Minor modification to add preschool use 810 sqft (indoor) Summer 2025
4750 sqft (outdoor)

CITY FILE NUMBER	CHANGES TO PLANS	APPROVAL DATE
CPC DP 02-0253:	Beth-El Mennonite Church Development Plan	(2002)
AR NV 09-00036:	nonuse variance for additional wall signage	(2009)
PDZ-25-0020:	minor modification to add preschool use	(Summer 2025)

Beth-El Mennonite Church

UPDATED 5-9-25

1 OF 15 SHEETS

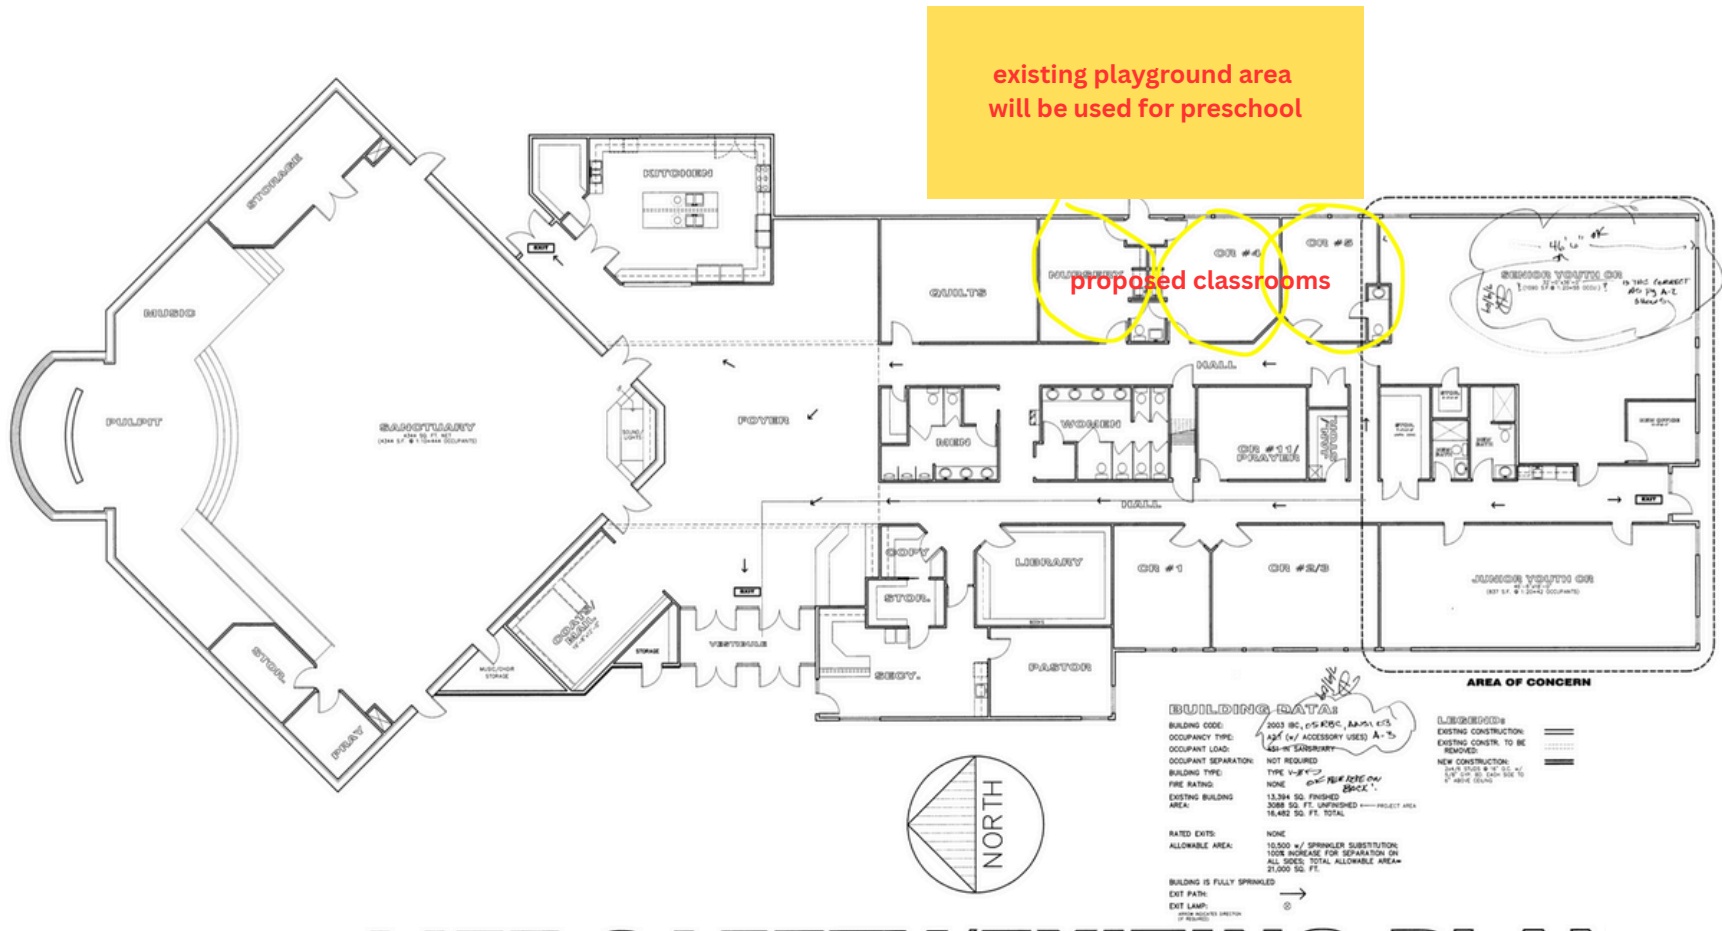
Existing Zoning: ~~PDZHS - Religious Institution~~

1. Use shall be limited to ~~Religious Institution (Church) only (other)~~

LAND USE: ~~RELIGIOUS INSTITUTION~~

Religious institution and child daycare center, large

RELIIGIOUS INSTITUTION:	REQUIRED SPACES	PROVIDED
Proposed Sanctuary Seating: 310 seats	114/5 H.C.	
Proposed preschool size 25 children	52	20
